RE : P G & E TOPOCK COMPRESSOR STATION
FILE :

1. CALIFORNIA DEPARTMENT OF HEALTH SERVICES

FIGURE 3

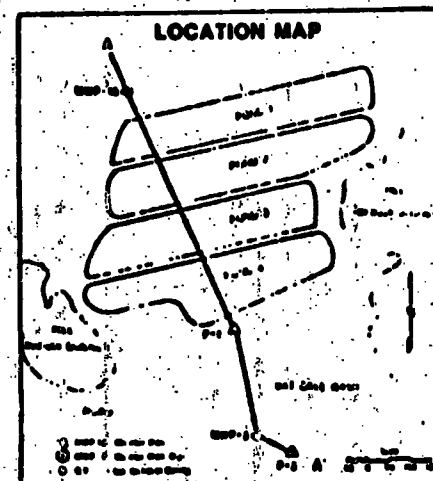
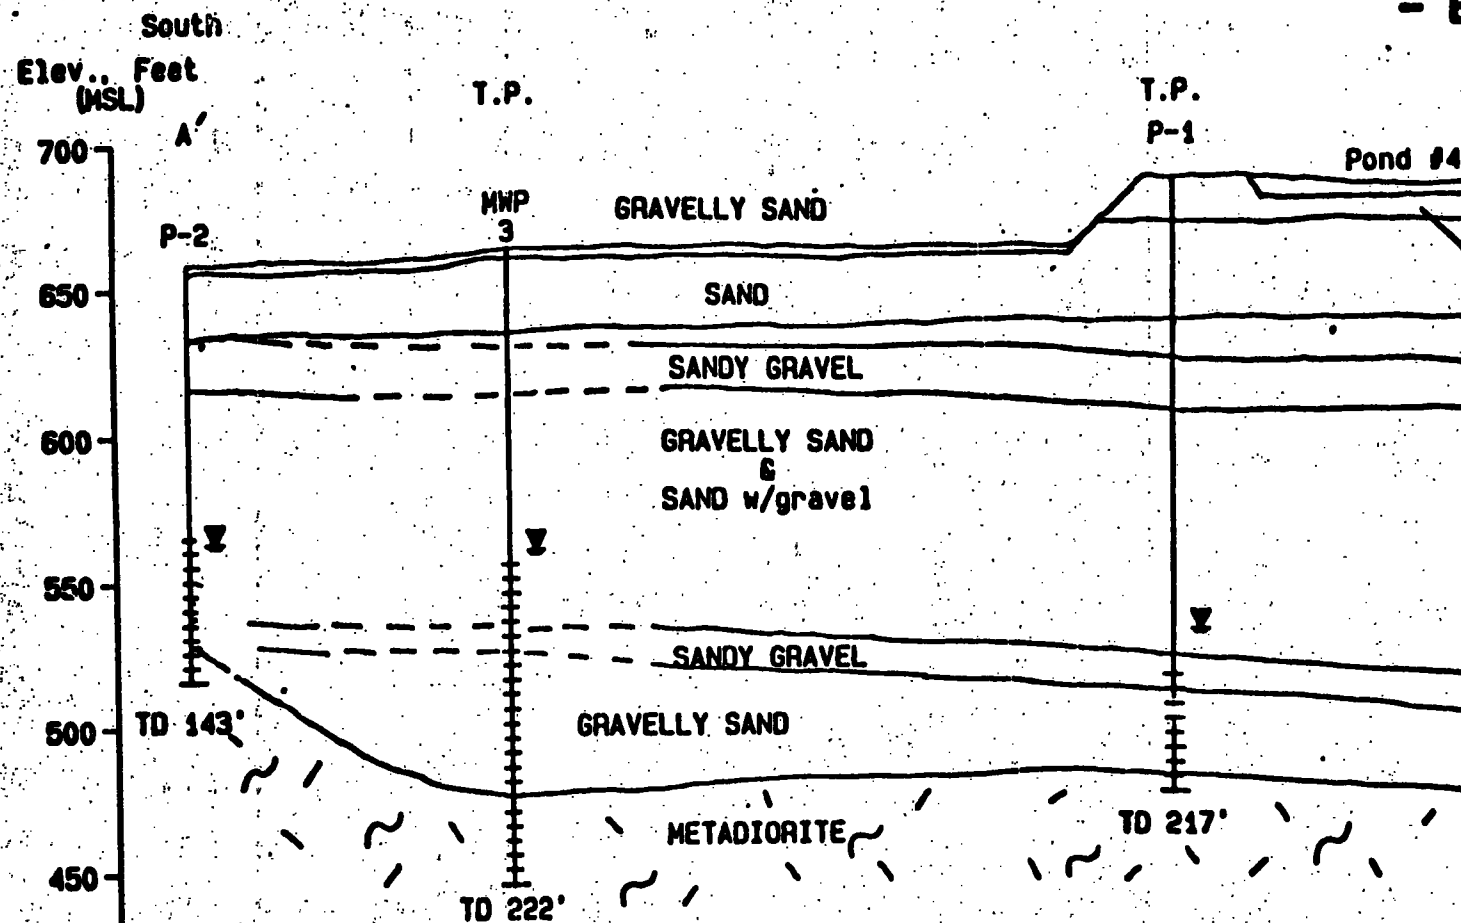
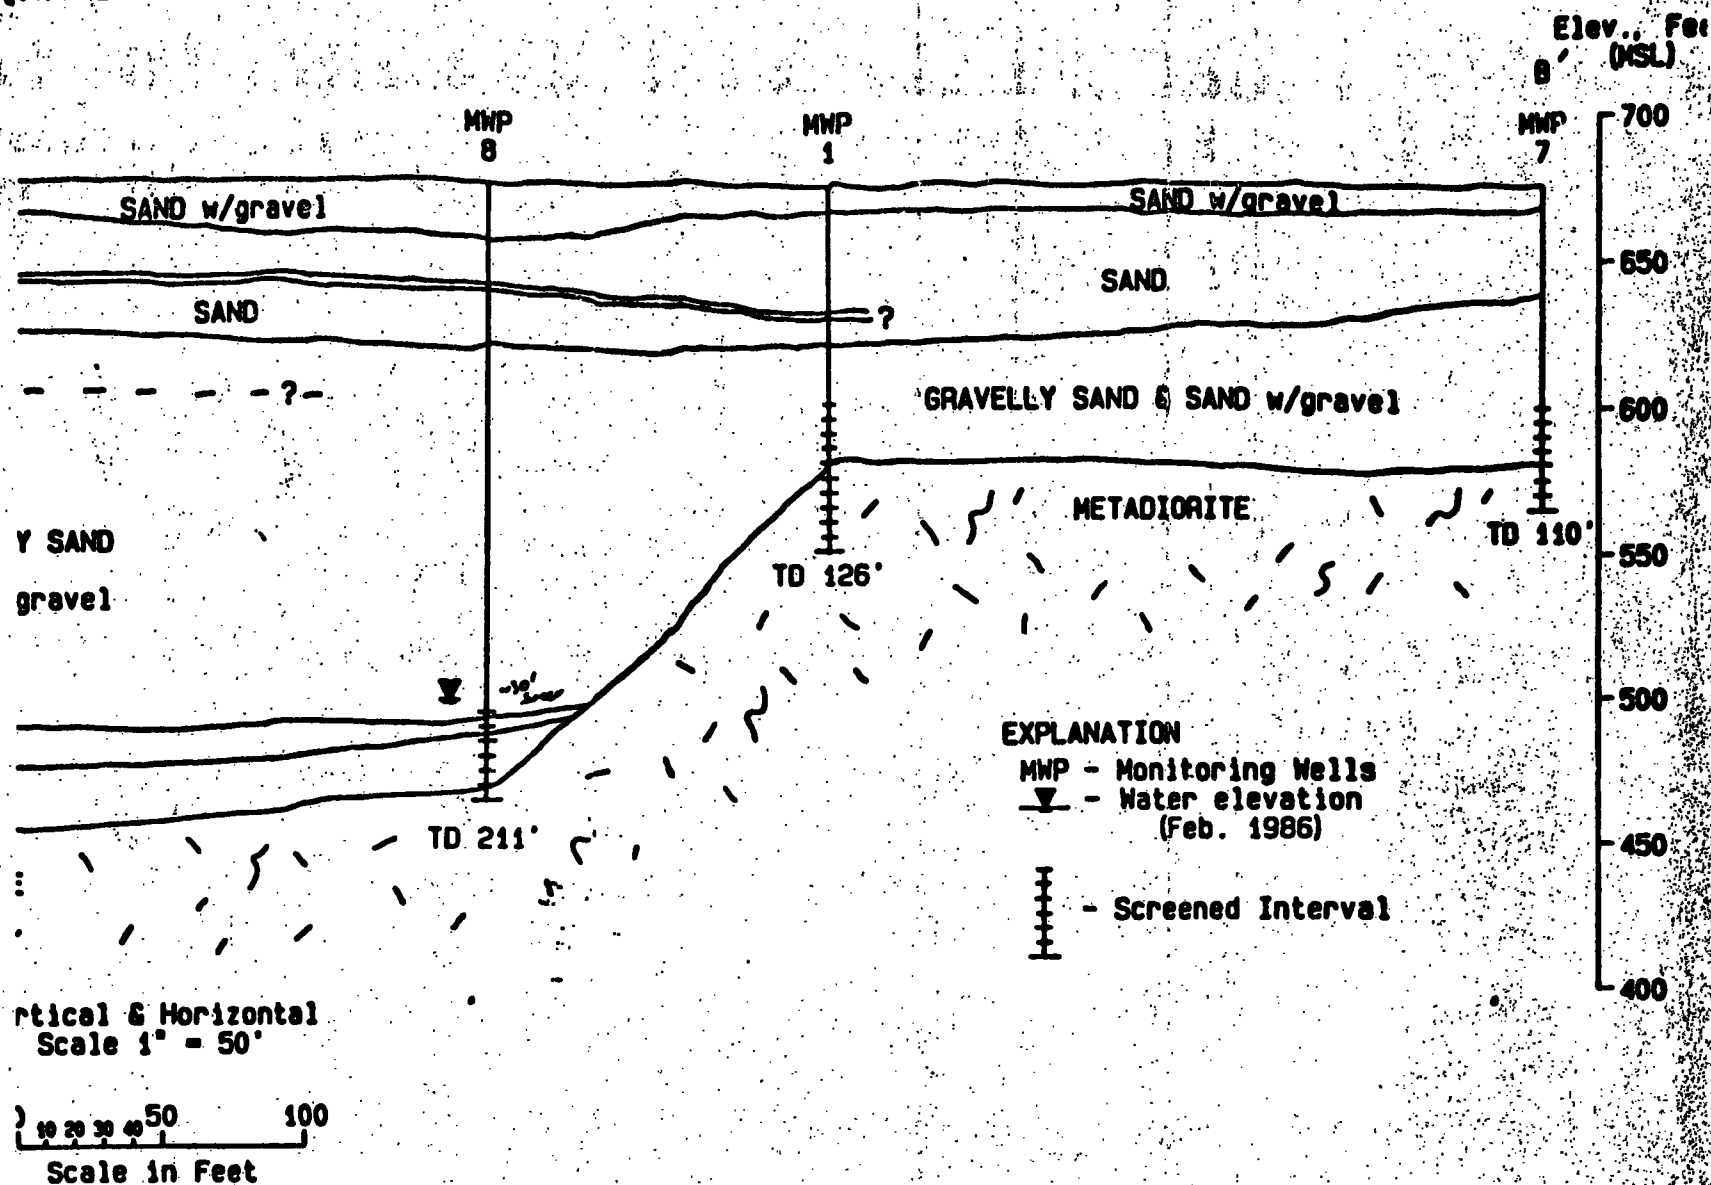
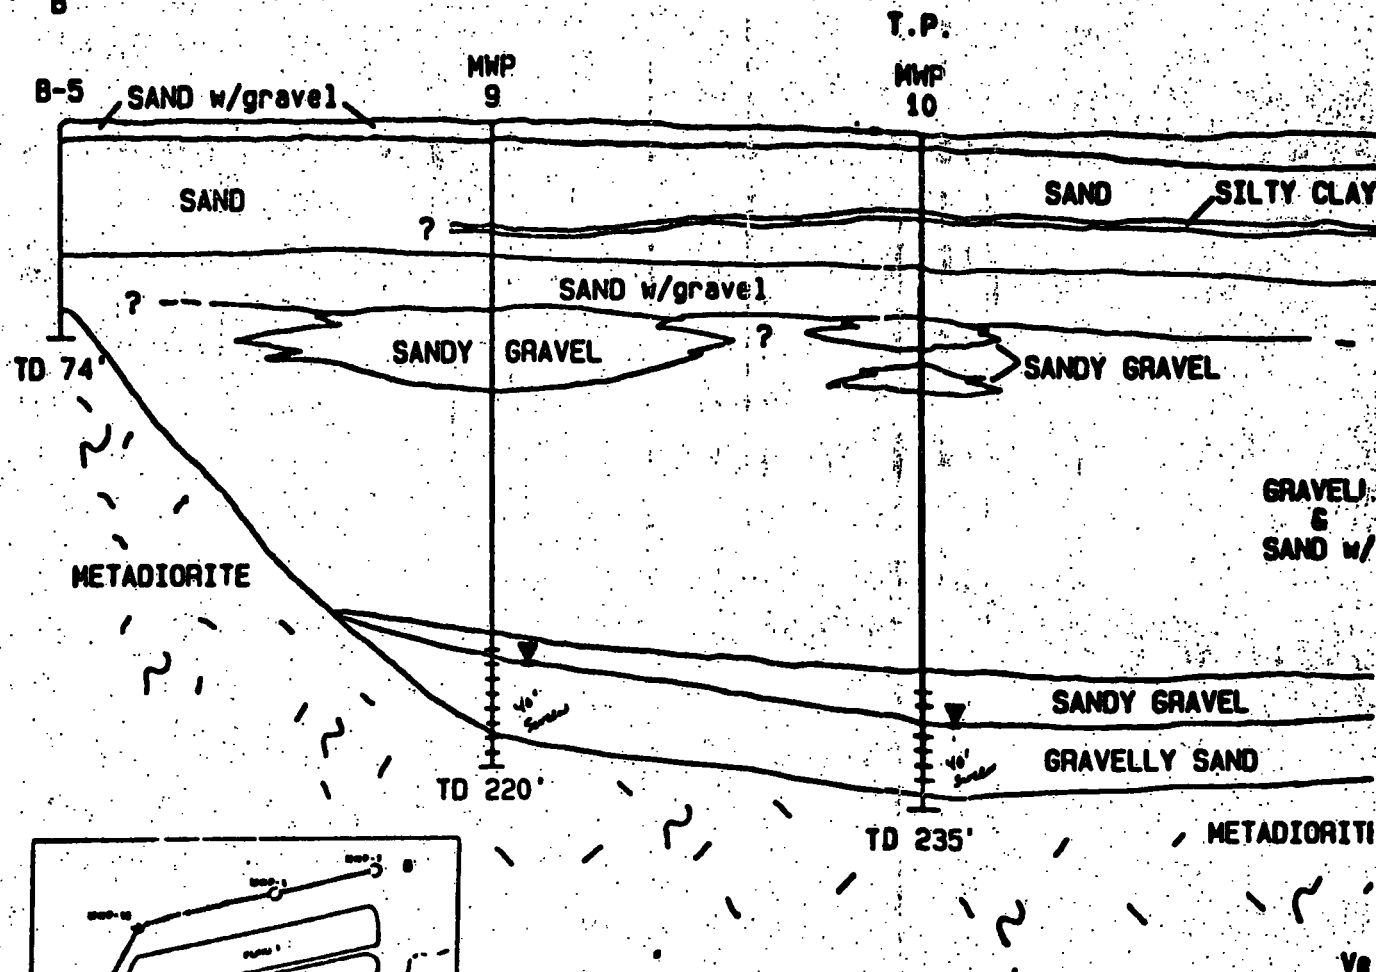
The number of geologic cross-sections developed were inadequate for defining the site stratigraphy. Only two cross-sections were made (one N-S and one E-W). The accuracy of the N-S cross-section is questionable because the lithology was interpolated over too great a distance beneath the impoundments (i.e. from P-1 to MWP-10 = 550 feet).

14. Additional borings nearer the impoundments and along the median dike would provide the necessary information to adequately define the stratigraphic relationships beneath the site. (Provided that continuous coring and finally, gamma logging is done on each well or boring to effect correlation between the wells.)

Figure 6

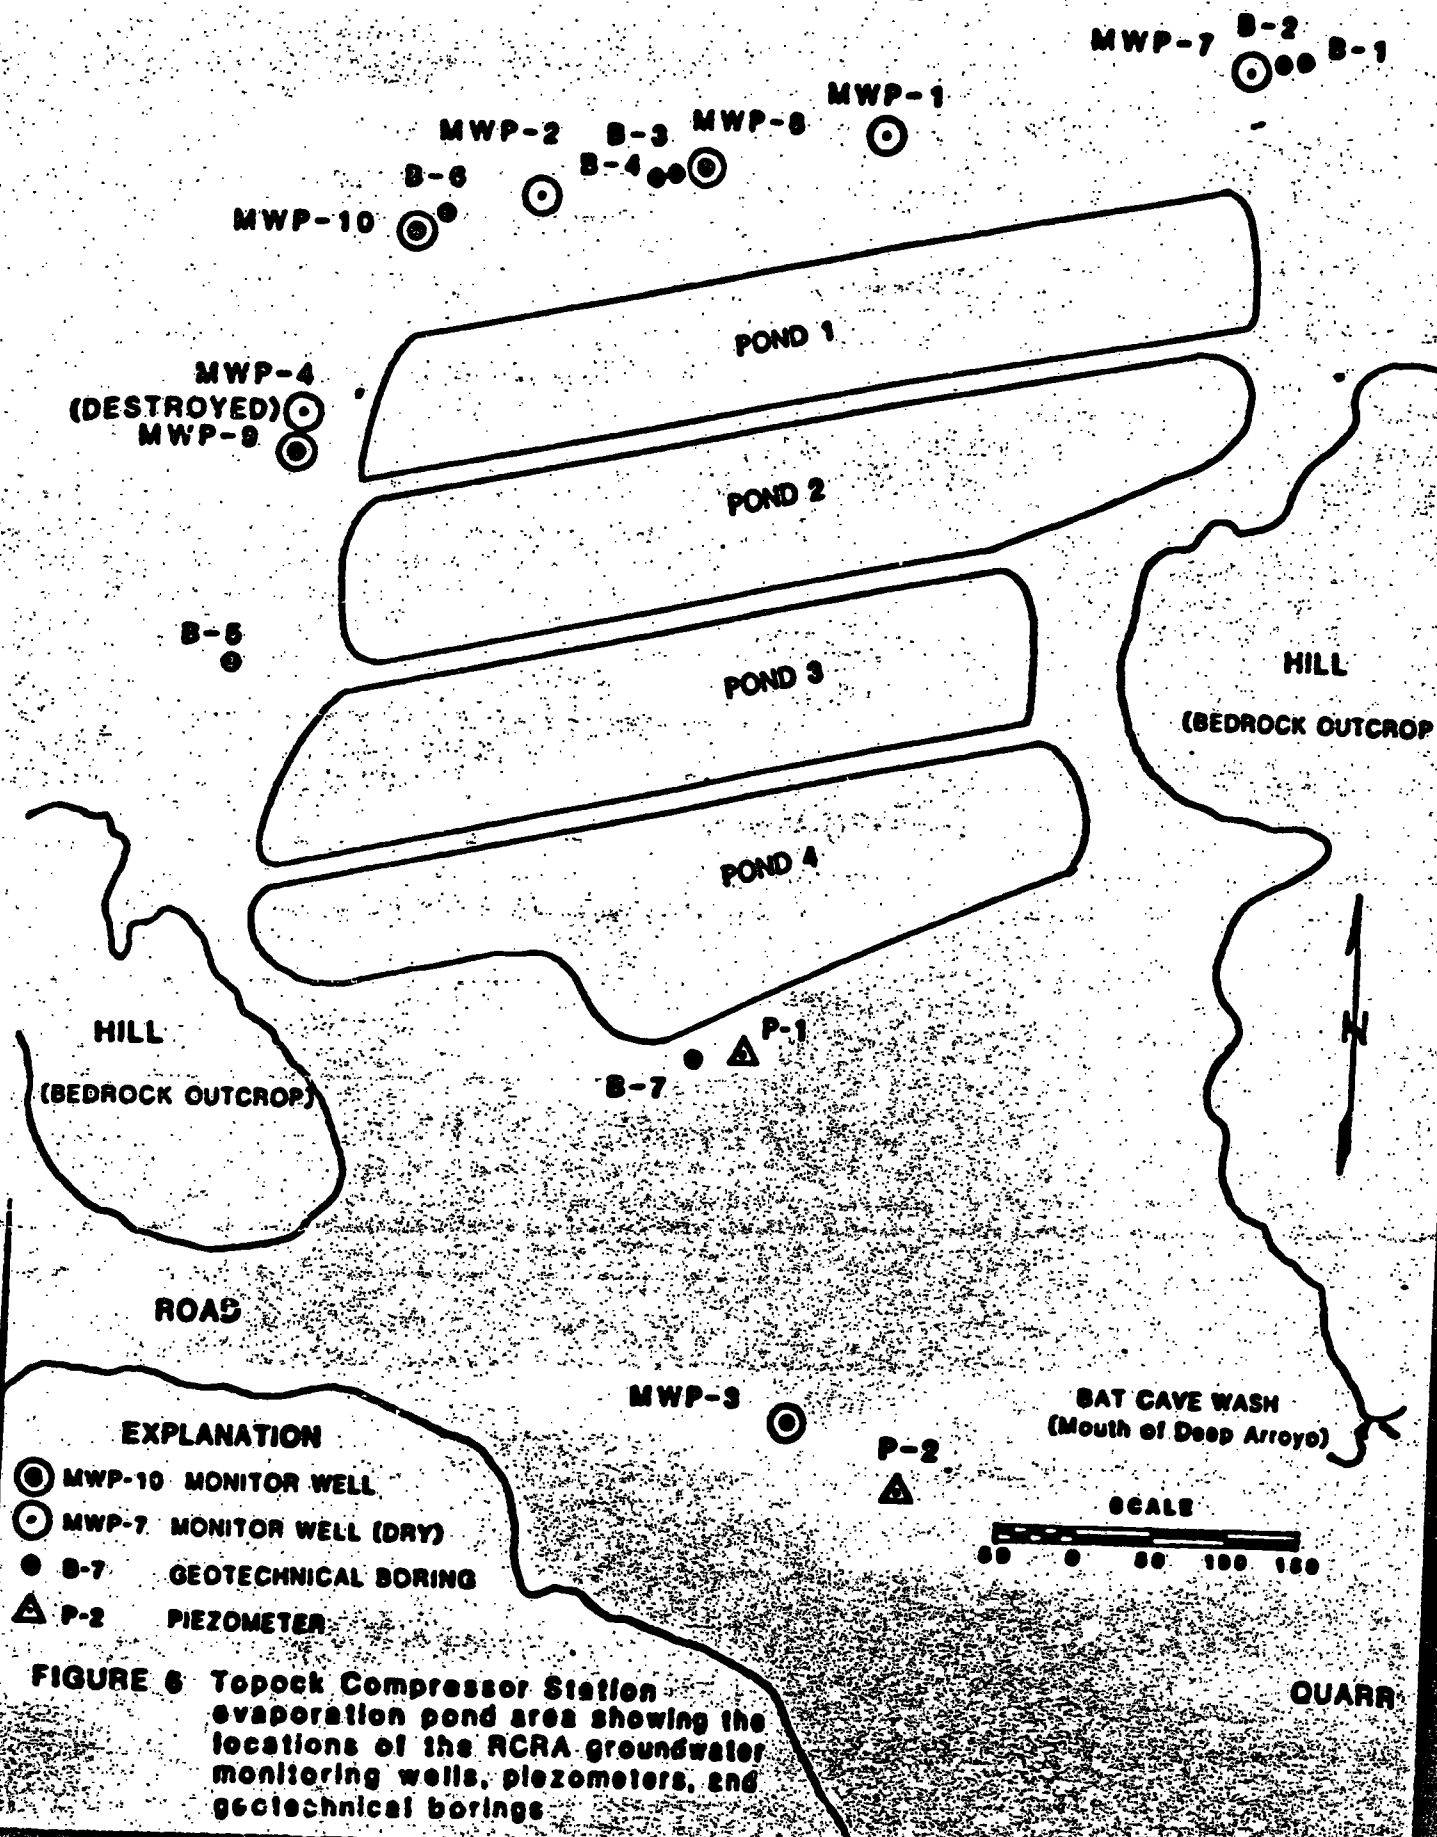
5. & 6. To provide a basis for understanding the site's subsurface, and to support the placement of monitoring wells, the discharger conducted 17 geotechnical borings and a seismic refraction survey. Gamma ray geophysical logs were run on monitoring wells MWP-2, MWP-7 and MWP-10. However, the results of said borings and investigations failed to adequately define the uppermost aquifer and to yield enough information for the proper placements of all the wells. The study did yield sufficient information to determine the general upgradient and downgradient position of the wells. Additional borings are required near the impoundments and median dikes in order to adequately define the stratigraphy beneath and around the impoundments and to estimate the width of the uppermost aquifer beneath and immediately beyond the impoundments. The discharger needs to show by installation of additional sampling wells whether the thin moist to wet zones in the higher alluvial deposits could yield enough water for sampling. This information would aid in defining the true uppermost aquifer.

Figure 8

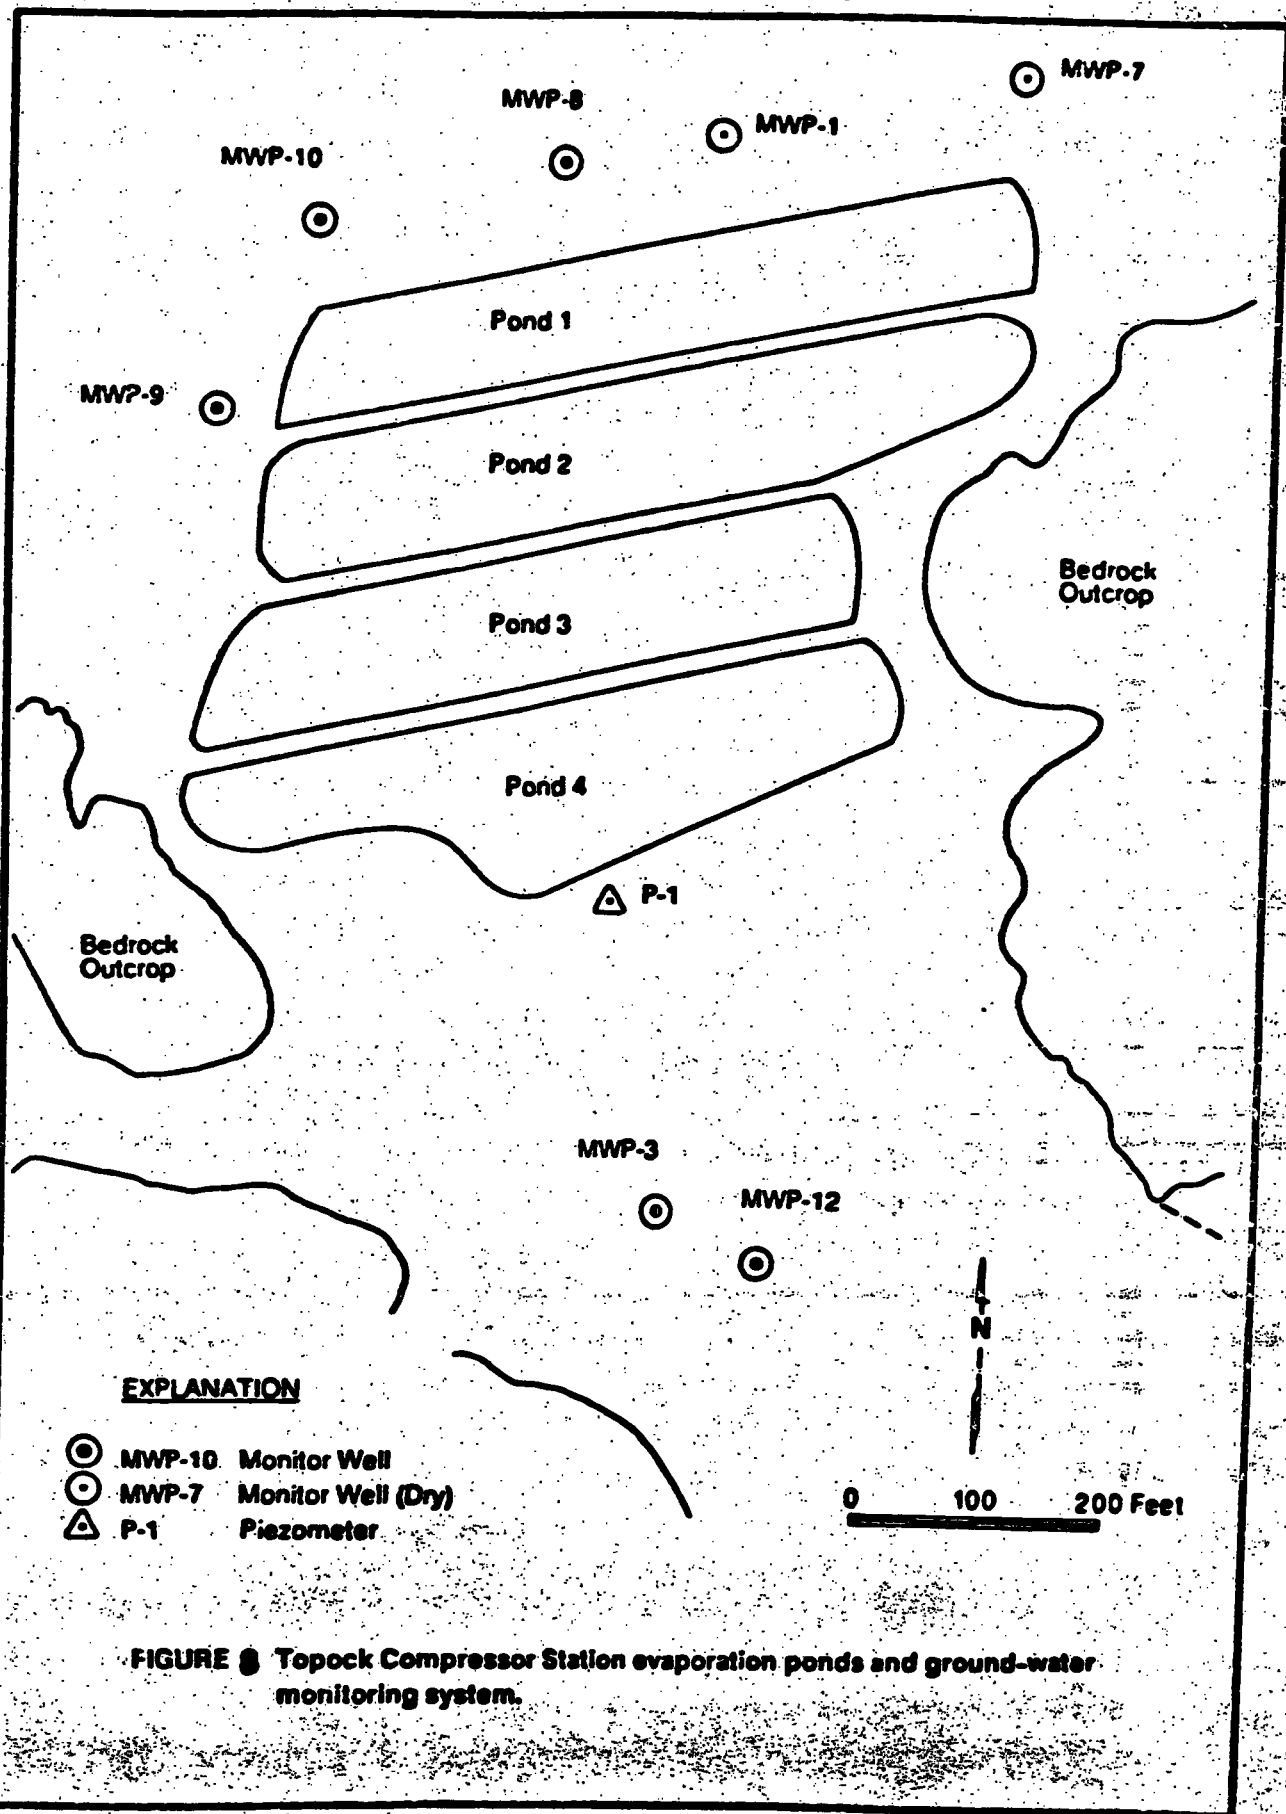
20. Since the site hydrogeology is not adequately understood, it is not possible to comment on an adequate number of downgradient monitoring wells (their locations and screen depth) that would be required. However, based on the available information, the number of downgradient monitoring wells appears inadequate. It is not certain whether MWP-8 is screened in the same aquifer as the remaining wells, so additional clustered piezo meters may be needed to replace MWP-8, and also to investigate the anomaly relating to MWP-8. The distance between MWP-8 and MWP-10 is about 200 feet. An additional monitoring well located equidistant from MWP-8 and MWP-10 appears to be necessary.
